ADDENDUM No. 2

Date: June 4, 2026

Project: Grand Forks International Airport
Reconstruct Runway 17R/35L – South & Middle Portion

1. Sheet E-615 – Electrical Details – Addendum 2

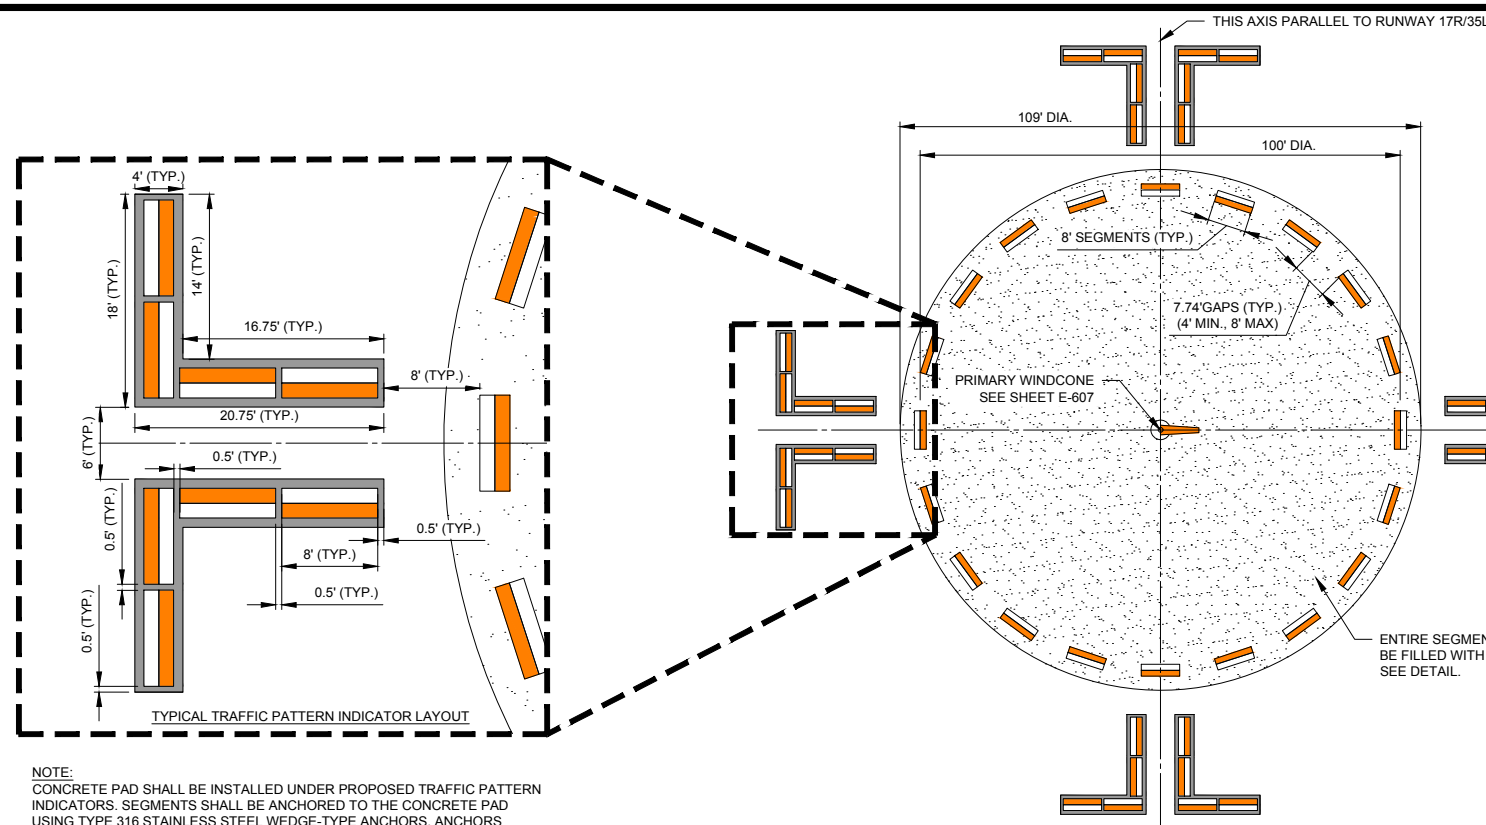
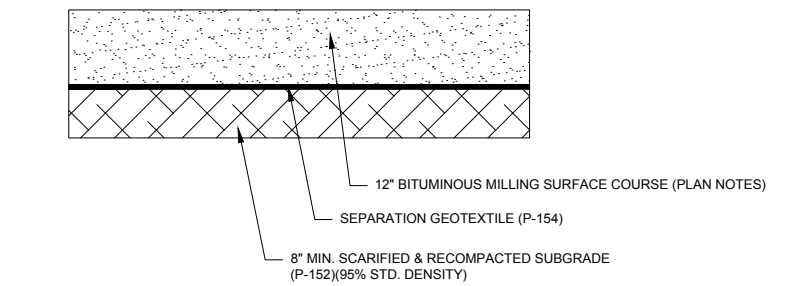
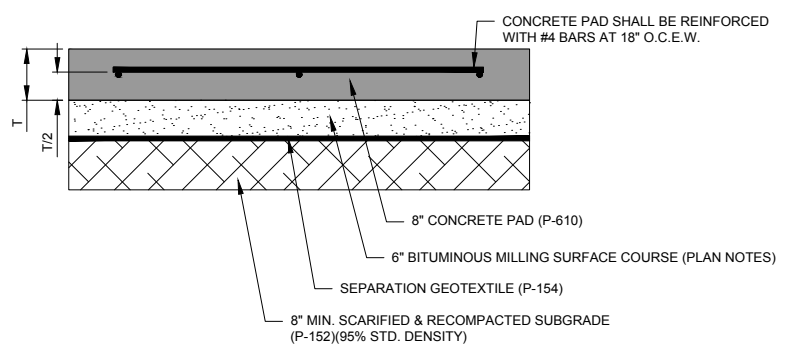
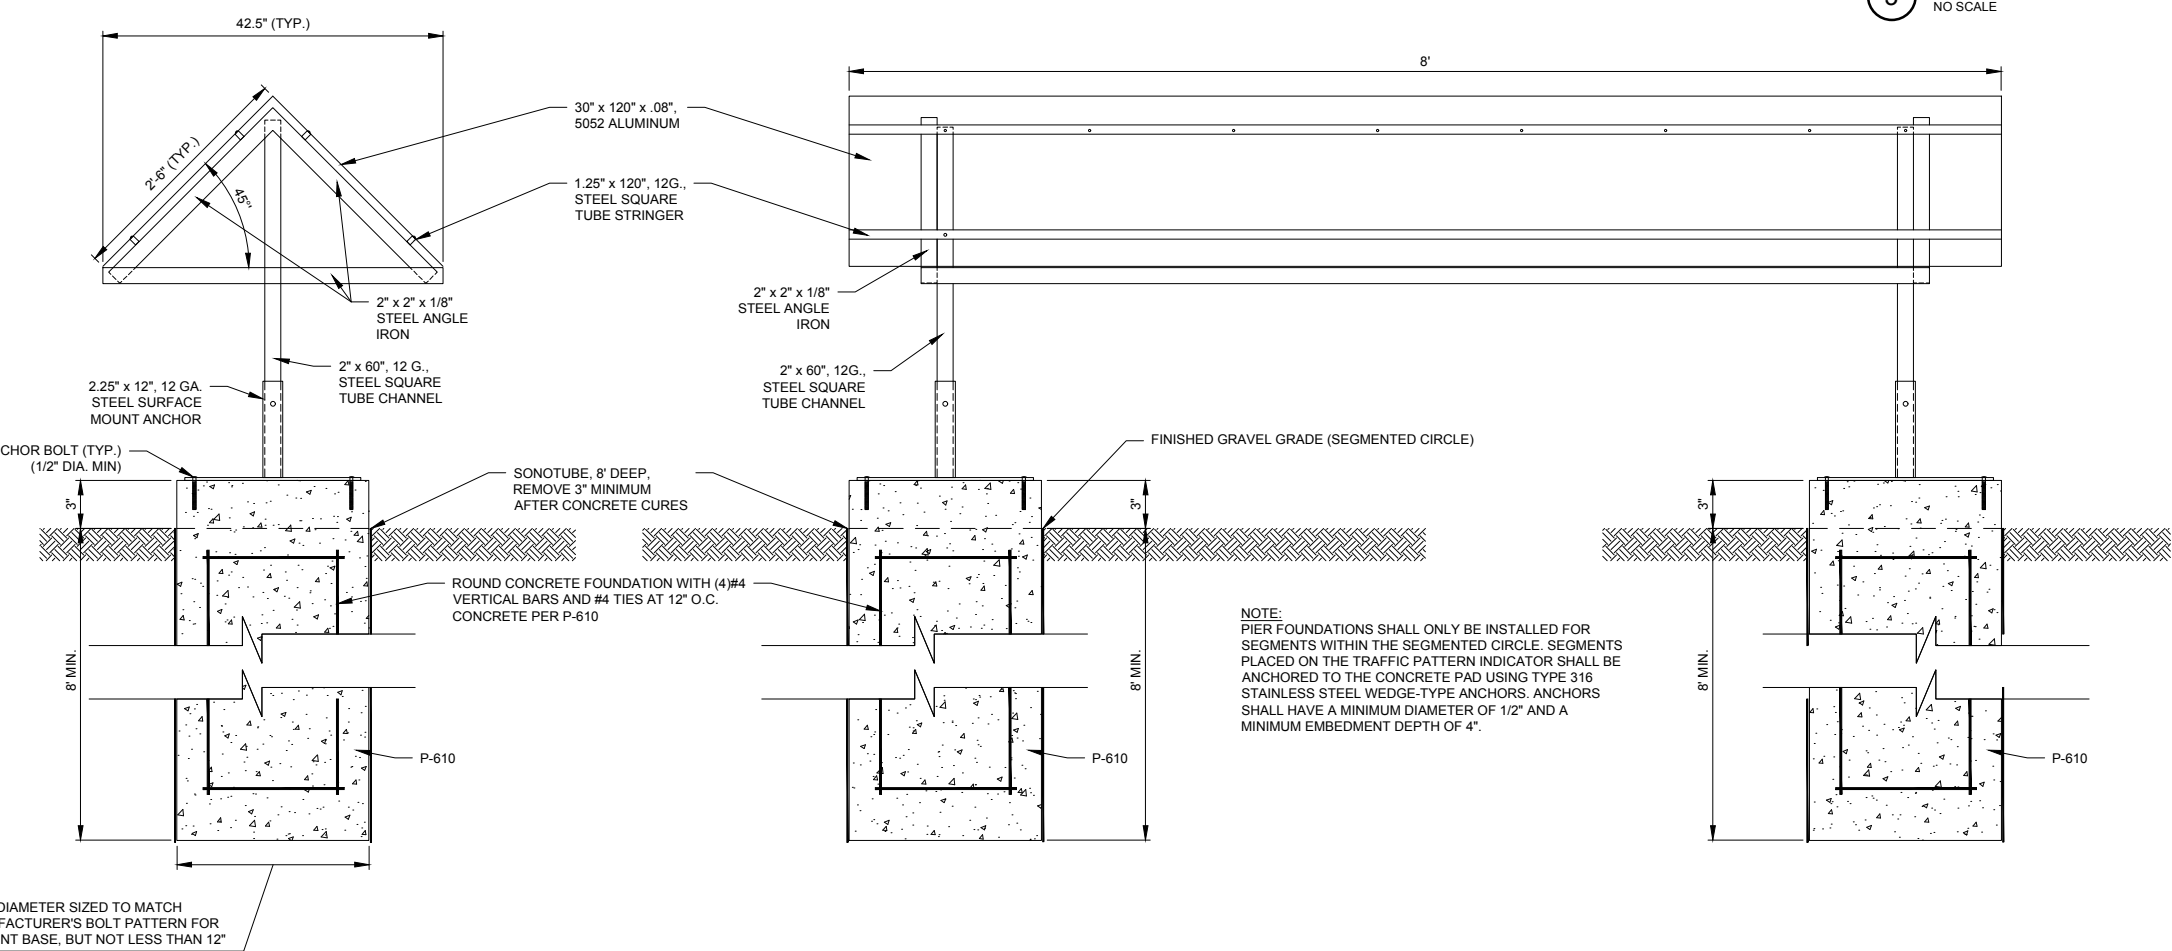
- 1.) Issue new Sheet E-615. Changes include:
 - a. The Engineer was recently made aware of difficulty obtaining the originally-specified 10’ segments for the Segmented Circle and Traffic Pattern Indicators. The layout shown on Sheet E-611 (with 10’ segments) is preferred, but if the Contractor is unable to obtain 10’ segments, the layout shown on the new Sheet E-615 (with 8’ segments) is acceptable.
- 2.) Attach Bidder Questions received as of 06/03/2026.

- A. Issue new sheet.
- B. Changes include:
 - I. Included new layout for Segmented Circle and Traffic Pattern Indicators if the Contractor is only able to obtain 8' segments.

THE ENGINEER WAS RECENTLY MADE AWARE OF DIFFICULTY FINDING THE ORIGINALLY-SPECIFIED 10' SEGMENTS FOR THE SEGMENTED CIRCLE. THE LAYOUT SHOWN ON SHEET E-611 (WITH 10' SEGMENTS) IS PREFERRED, BUT IF THE CONTRACTOR IS UNABLE TO OBTAIN 10' SEGMENTS, THE LAYOUT DETAILED ON THIS SHEET (WITH 8' SEGMENTS) IS ACCEPTABLE.

NOTE:
CONCRETE PAD SHALL BE INSTALLED UNDER PROPOSED TRAFFIC PATTERN INDICATORS. SEGMENTS SHALL BE ANCHORED TO THE CONCRETE PAD USING TYPE 316 STAINLESS STEEL WEDGE-TYPE ANCHORS. ANCHORS SHALL HAVE A MINIMUM DIAMETER OF 1/2\" AND A MINIMUM EMBEDMENT DEPTH OF 4\".

NOTE:
PIER FOUNDATIONS SHALL ONLY BE INSTALLED FOR SEGMENTS WITHIN THE SEGMENTED CIRCLE. SEGMENTS PLACED ON THE TRAFFIC PATTERN INDICATOR SHALL BE ANCHORED TO THE CONCRETE PAD USING TYPE 316 STAINLESS STEEL WEDGE-TYPE ANCHORS. ANCHORS SHALL HAVE A MINIMUM DIAMETER OF 1/2\" AND A MINIMUM EMBEDMENT DEPTH OF 4\".
